REMARKS

Claims 1-41 are pending in this patent application, and claims 15 and 34-40 have been previously withdrawn from further consideration. By this amendment, claims 1-18 and 34-41 have been canceled, claims 19, 20, 21, 22, 24, 25, 26, and 30 have been amended, and claims 42-52 have been added. Reconsideration of this patent application, as amended, is respectfully requested.

Amendment to Drawings

Fig. 5

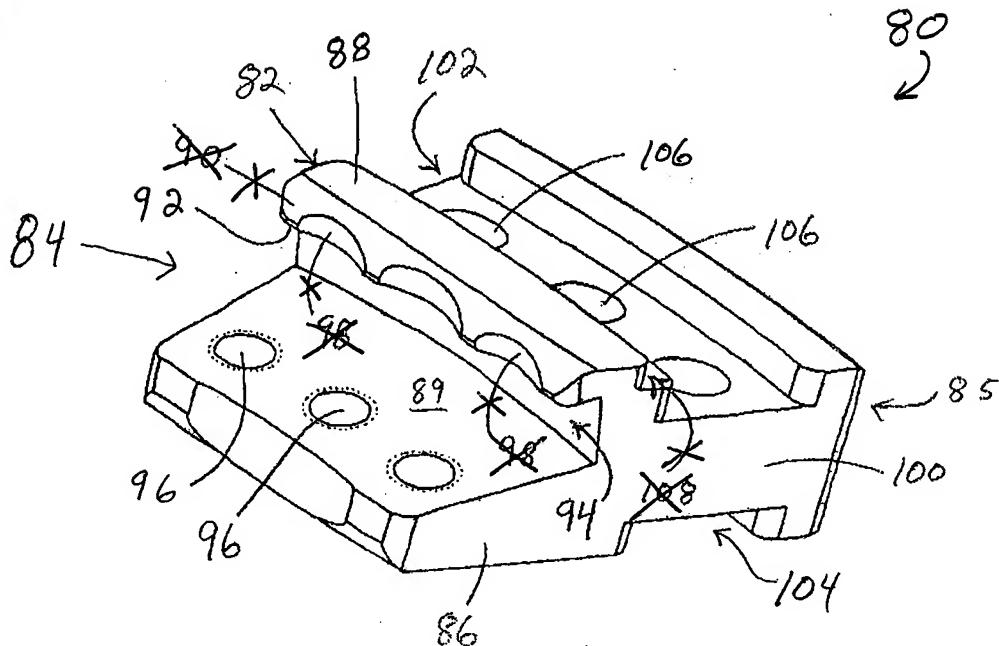
In accord with the Examiner's comments, Figs. 5, 6, 12, and 16 have been amended to remove the following reference numerals and their associated lead lines: 26a, 32a, 238b, 238a, 98, 90, and 108.
